**From:** Richard Lanser <lanserricke@gmail.com>  
**Sent:** Tuesday, April 22, 2025 9:38 AM  
**To:** ZZ Council Members  
**Subject:** 25-0413 proposed grading  
**Attachments:** Existing grading.jpeg; Proposed grading.jpeg

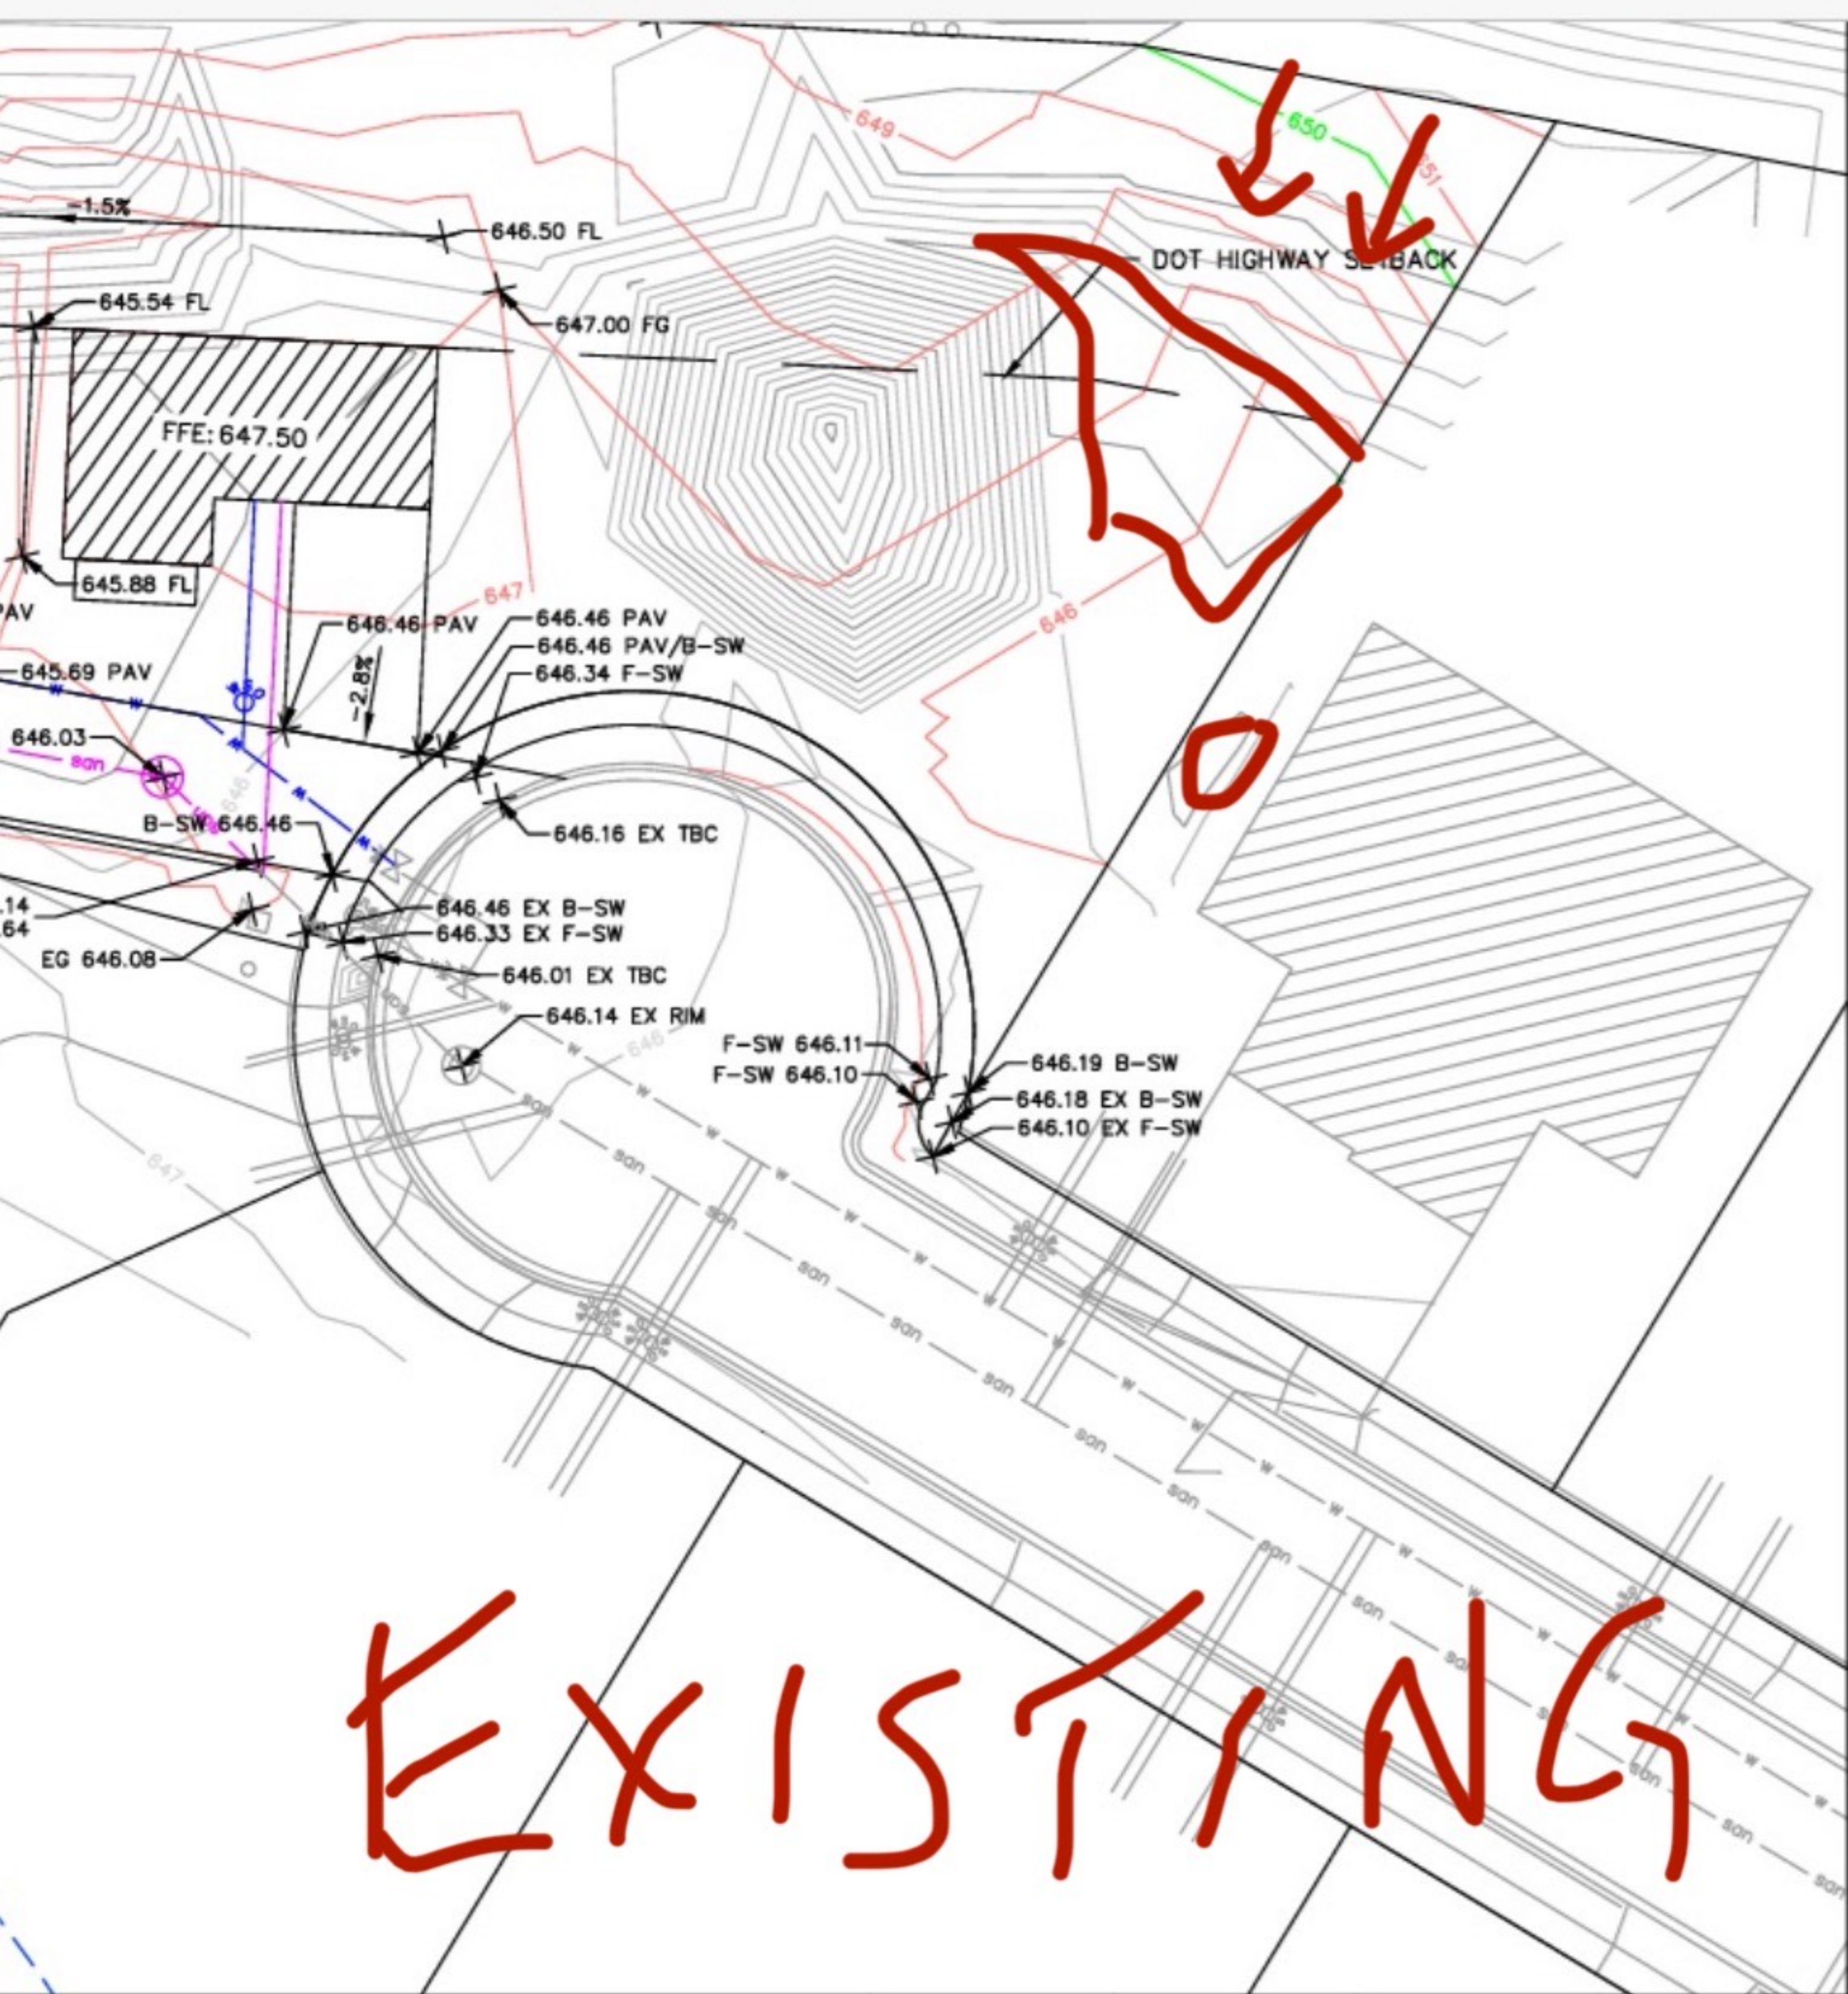
I am the owner of 6005 River Run Road which abuts the proposed Common Space. I have attached jpegs which show existing grading and the proposed grading. Water currently stays in the Common Space. The grading plan of the proposed Common Space will create a low area which is partly on my property which will pond at certain times of the year. The height of the sidewalk will prevent the water from escaping.

I would ask that the grading plan be altered so the low lying area be moved to the interior of the Open Space.
